An Bord Pleanála
Strategic Infrastructure Division
64 Marlborough Street
Dublin 1
D01 V902

RE: Objection to Application for Approval of a Proposed Road - CLONGRIFFIN TO CITY CENTRE CORE BUS CORRIDOR SCHEME – at Artane Cottages Lower, by the National Transport Authority, Case Ref. HA29N.313182

Fig. 2 – Preferred Route Option Report, Appendix G (consultation 1), map 15 (extract)

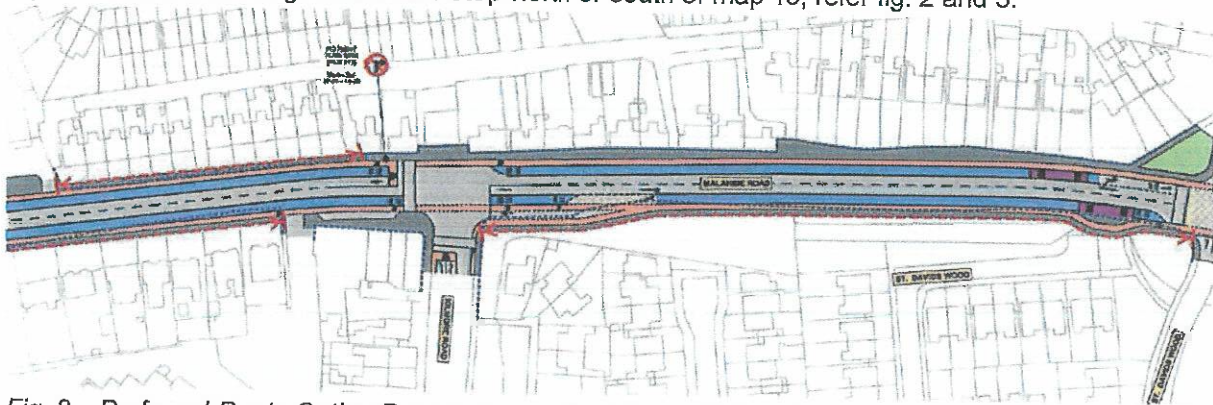
The bus stop Danieli Road (1219) was removed prior to consultation 1. Between consultations 1 and 2, a previously revised bus stop Killester Avenue (1220) was removed, both crucially without replacement or an amalgamated new stop north or south of map 15, refer fig. 2 and 3.

Fig. 8 – EIA Appendix A4.1 - Preliminary Design Guidance Booklet for BusConnects Core Bus Corridor, figure 36: Shared Bus Stop Landing Zone Arrangement (Urban Centres)

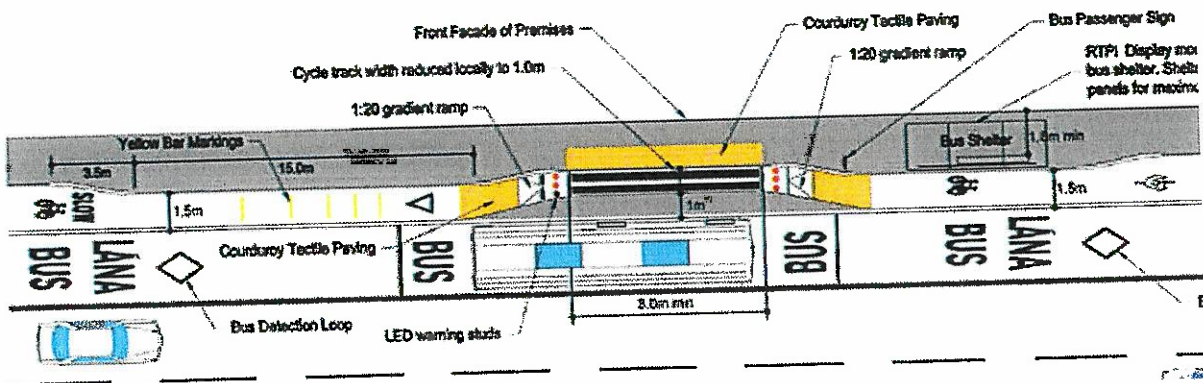
The design in fig. 36 of Appendix A4.1 (here Fig. 8) is quoted as being permissible only in "particularly constrained" situations within "urban centres", which implies it would be outside commercial premises. While the footpath at nos. 5 & 6 Artane Cottages Lower certainly is extremely constrained, there are alternative locations within 65m south or 190m north which are not, refer section 3.4. The site is not located within an urban centre, not even within a suburban one.

Please also note that while the overall dimensions shown in Fig. 8 were used in the proposed stop at nos. 5 & 6 Artane Cottages Lower, the design guidelines at fig. 36 crucially still include a bus shelter close to the stop – bus stops without bus shelters, as proposed at Artane Cottages Lower, are not considered appropriate anywhere in the NTA's own design guidelines. Note that the proposed layout at Artane Cottages Lower also does not follow through on the NTA's commitment to retain the full depth (3.5m) of the existing footpath.

It is worth noting that the Island Bus Stop Arrangement (fig. 7) as per NTA guidelines allows for these dimensions, but not the applied compromised Shared Bus Stop Landing Zone Arrangement (fig. 8).

The above clearly demonstrates that embarking / disembarking of the bus (at all bus stops along the route designed in line with fig. 8 above) will not be possible without an increased risk of accidents between pedestrians / wheelchair users and cyclists. In a physically constrained location as at Artane Cottages Lower, any such accident would occur less than 3m from the front elevations of single storey residential property.
